2016 Ford Mustang V8-5.0L

SYNC 3 – NO REAR VIEW CAMERA IMAGE AT FREEZING AMBIENT TEMPERATURES - BUILT ON 01-JUL-2015 AND THROUGH 31-DEC-2016

17-2068

18 April 2017

Figure 1

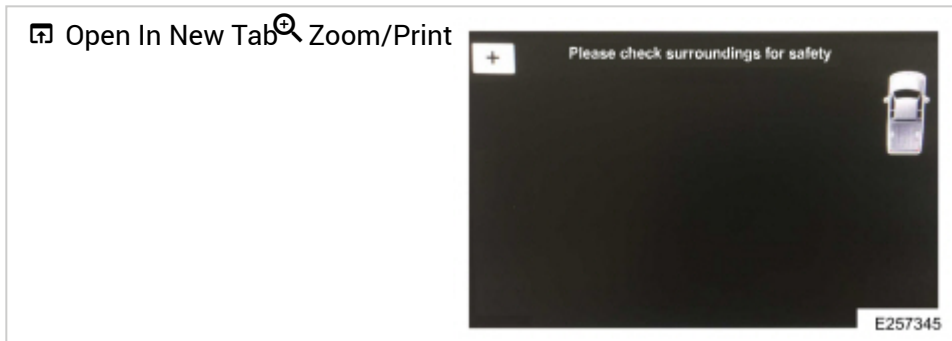
2. Is the customer reporting a SYNC display message of Please check your surroundings for safety along with no rear view camera image when in reverse gear which occurs during an ambient temperature range of -5 °C to 5 °C (23 °F to 41 °F)? (Figure 1)

3. Start the engine and set the heating ventilation air conditioning (HVAC) controls to maximum heat with blower speed on high. Run the engine until it reaches normal operating temperature. This will allow the accessory protocol interface module (APIM) to reach normal operating temperature. Is the SYNC system displaying a message of Please check your surroundings for safety along with no rear view camera image when in reverse gear (Figure 1)?

(2). No - replace the APIM. Refer to WSM, Section 415-00.
